UNITED STATES OF AMERICA  
NUCLEAR REGULATORY COMMISSION

In the Matter of:	)	Docket No. 72-22-ISFSI
	)	
PRIVATE FUEL STORAGE, LLC	)	ASLBP No. 97-732-02-ISFSI
(Independent Spent Fuel	)	
Storage Installation)	)	August 9, 1999

STATE OF UTAH'S STATEMENT OF MATERIAL FACTS  
IN DISPUTE REGARDING UTAH CONTENTION R

Figure 14

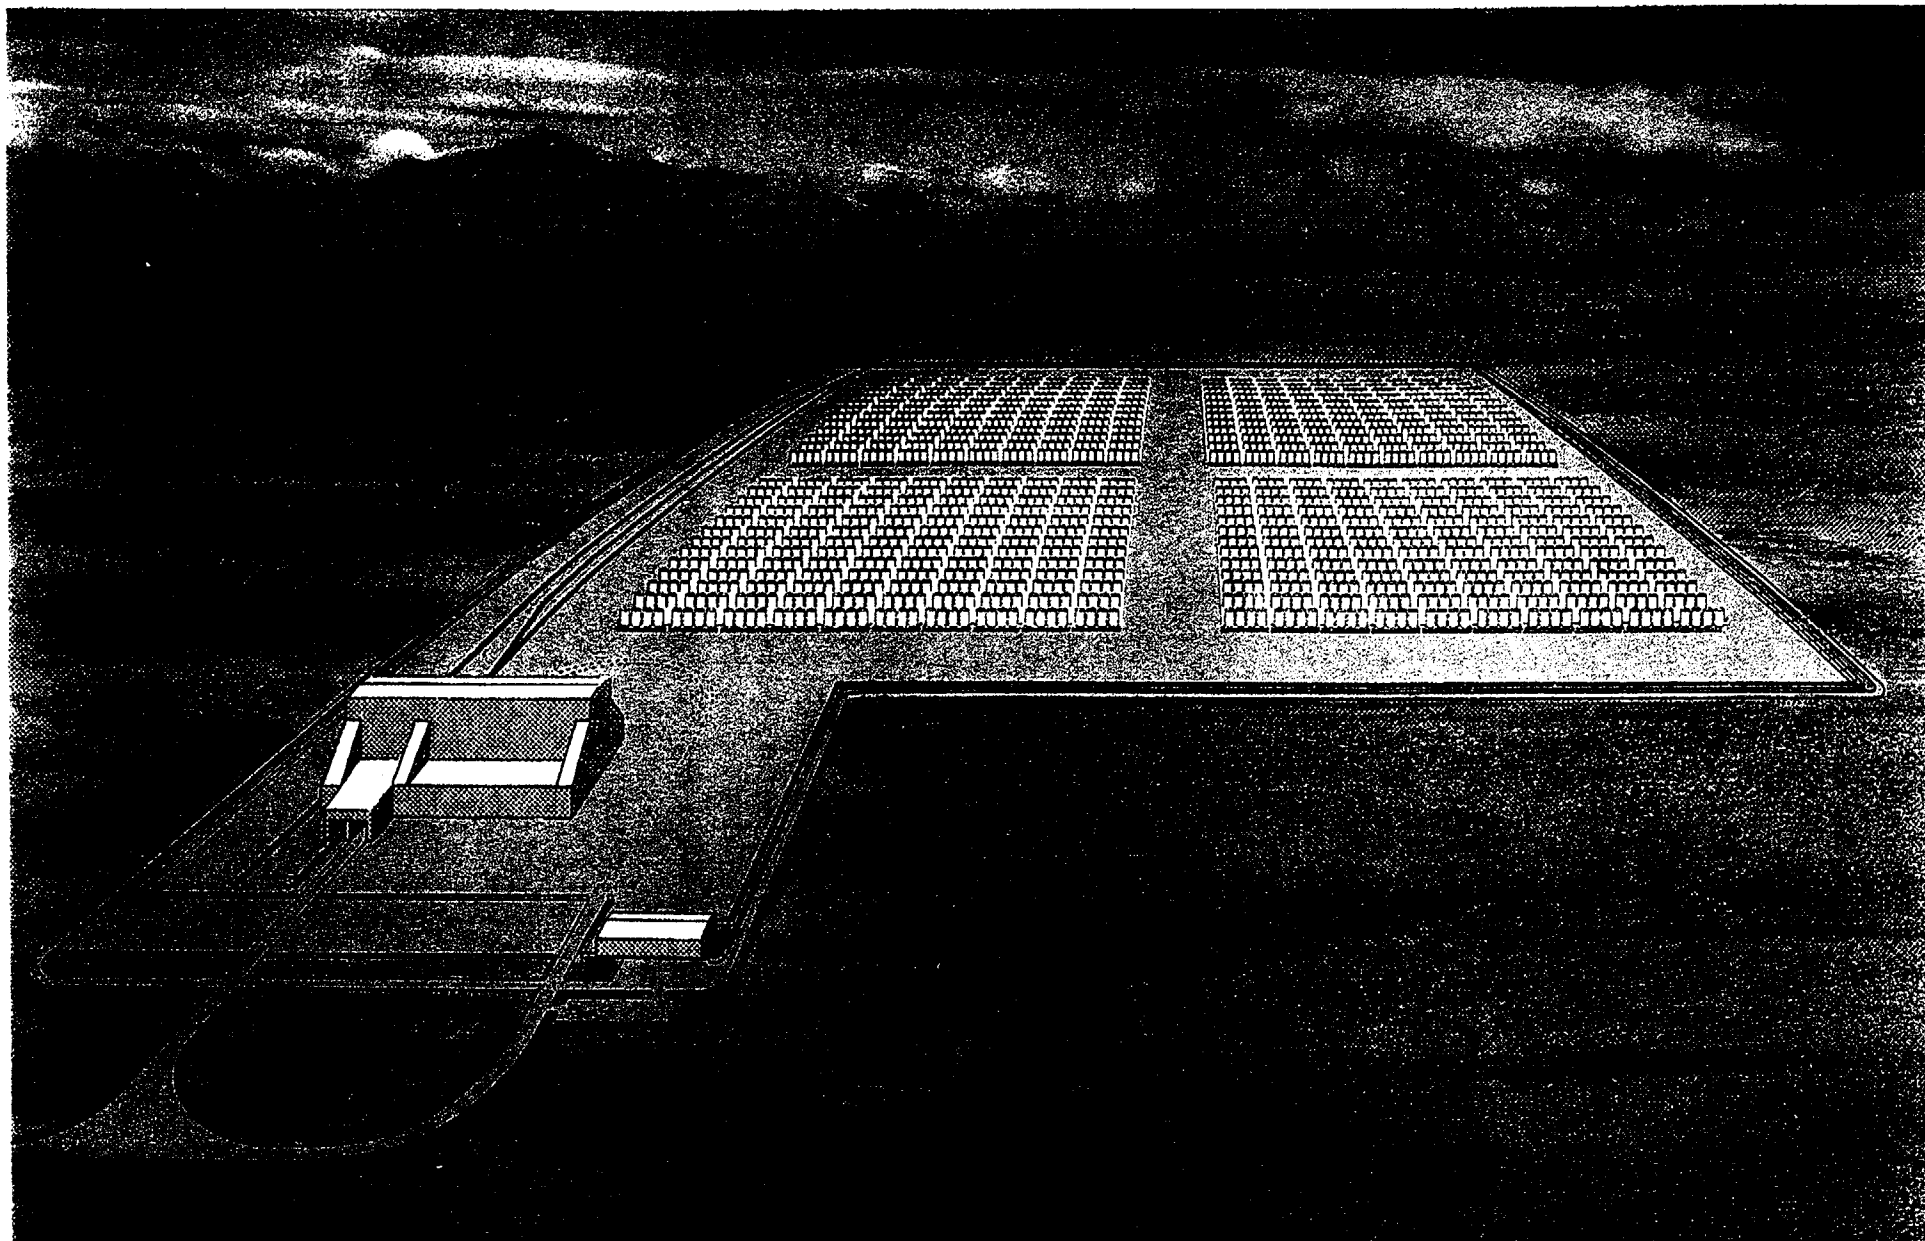
20. Figures 8 and 14 attached in support of Applicant's RAI response 14-1 dated February 8, 1999, show that railroad tracks enter and exit the Canister Transfer Building. See Attachment A to this Statement of Facts; *see also*, SAR Fig. 4.7-1
